**Camshaft Cover Oil Leaks – AJ16 Engine –
Revised Bolt Torque Specification**

MODEL 1995-96 MY
Sedan (4.0)Range
VIN
720001-767554

ILLUSTRATION 1

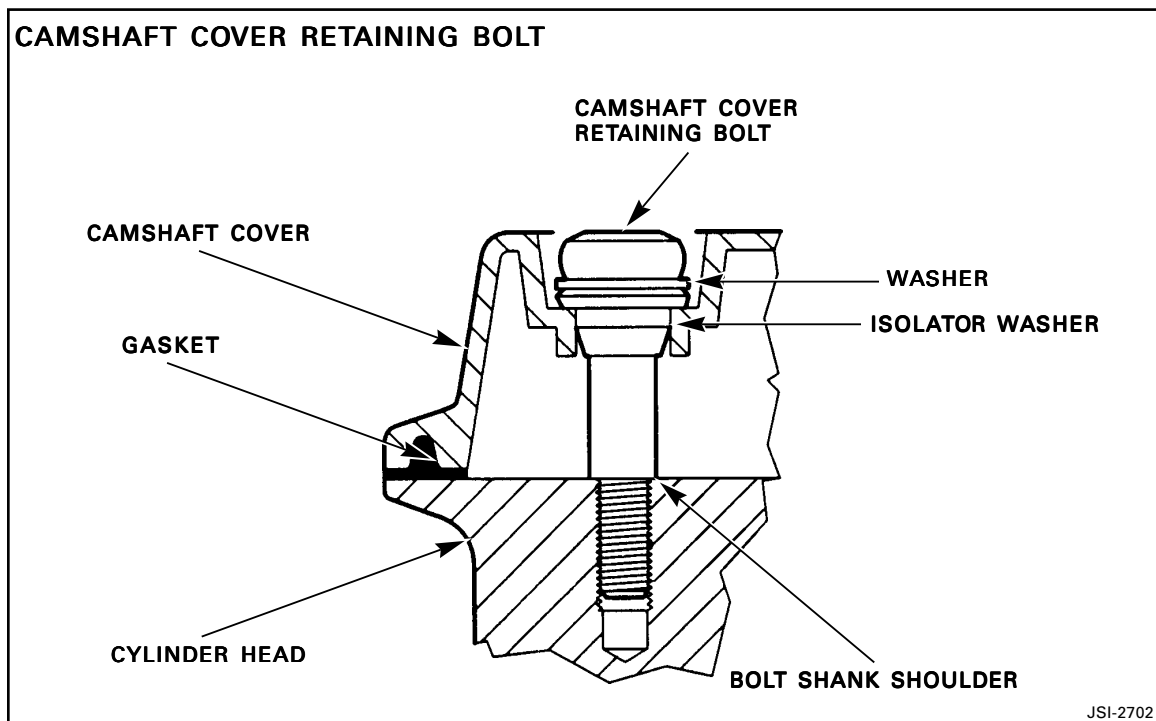
The torque specification for the camshaft cover retaining bolts has been revised beginning with VIN 767555. The revised torque specification ensures that the shoulder on the shank of the bolt bottoms against the surface of the cylinder head (Illustration 1) to achieve even compression of the camshaft cover gasket and to reduce the incidence of oil leakage.

The revised torque specification applies to **all** AJ 16 engines.

ILLUSTRATION 2

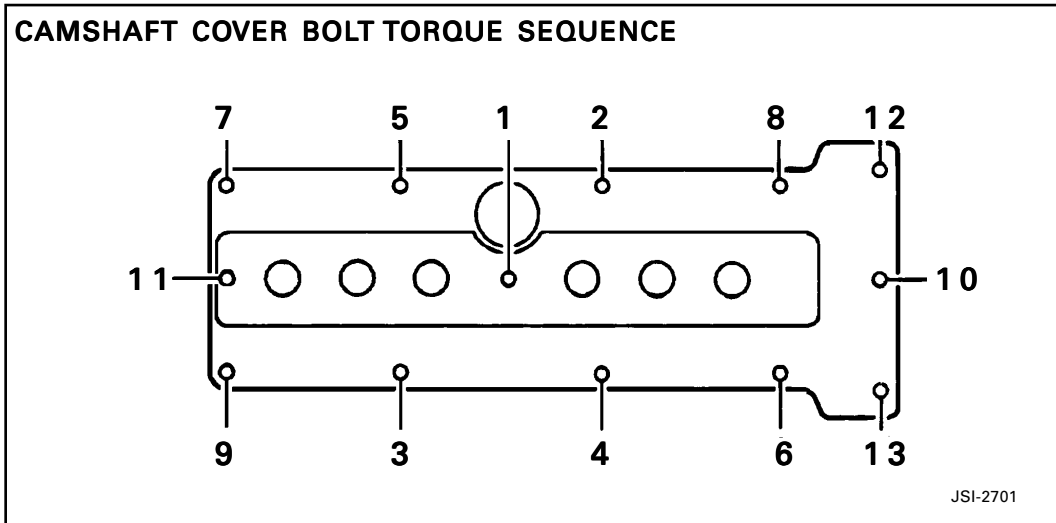
3. Install **new** seals in the spark plug wells.
4. Install a **new** camshaft cover gasket.
5. Install the camshaft cover and tighten the 13 retaining bolts "finger-tight."
6. Final tighten the retaining bolts in the sequence shown in Illustration 2
Torque the bolts to 5 lb. ft. (6.5 Nm).
7. Install new seals when reinstalling the "on-plug" ignition coils.
